Subject: Gemini and Apollo Spacecraft Controls and Displays

Date: September 6, 1963

MEMORANDUM FOR FILE

SUBJECT: Gemini and Apollo Spacecraft Controls and Displays

Figure 2. Representation of "M.I.T. configuration" on "8-Ball Display." Display shows vehicle to be in approximately an upright position.

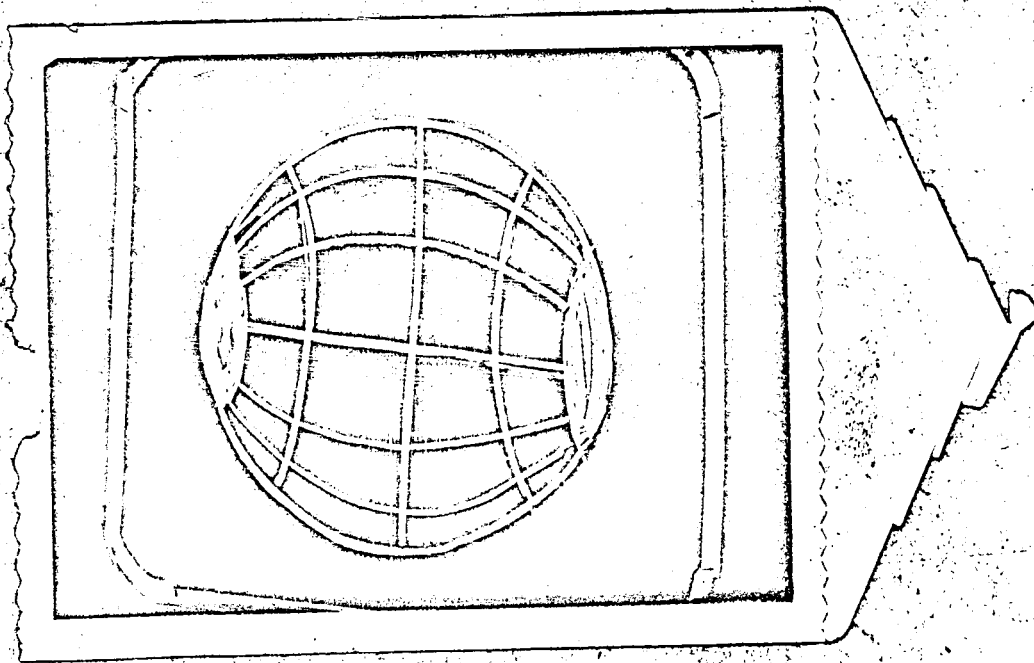
There is one portion in Mr. Low's memorandum (which apparently was written by Major Leroy Paige, a knowledgeable and competent expert in the human factors area) which points to a situation which may become a problem area. This question centers about the manner of marking the attitude ball indicator used to display vehicle attitude to the astronaut. As the NASA reviewer stated, "The difference between Gemini and Apollo will show up in the matter of location of the poles for the converging coordinates. In Gemini, the poles are at  $\pm 90^\circ$  pitch. Conventional 8 ball markings as drawn representatively in Figure 1 In the Apollo CM they are at  $\pm 90^\circ$  yaw, coincident with the areas of gimbal lock." M.I.T. configuration as schematized in Figure 2

The Bellcomm memorandum was chiefly interested in pointing out a potential source of unreliability resulting from this apparently innocuous  $90^\circ$  displacement of the points at which the coordinates converge. It might be noted that this problem area would never have cropped up if the M.I.T. guidance system were designed so that "all-attitude" operation in the CM could be safely undertaken. Nevertheless, the currently designed CM guidance is such that, in order to avoid gimbal lock, CM attitudes in the vicinity of  $\pm 90^\circ$  yaw must be avoided if the attitude ball is to operate reliably. Furthermore, given these constraints, the M.I.T. recommendations as to marking the face of the ball appears to be reasonable.

While this potential source of unreliability is more likely for CM/LEM differences, it also pertains to Gemini/Apollo differences if Gemini is to be used as a "training bed" for Apollo. It is most strongly urged that the ball markings on the LEM be consistent with those in the CM.
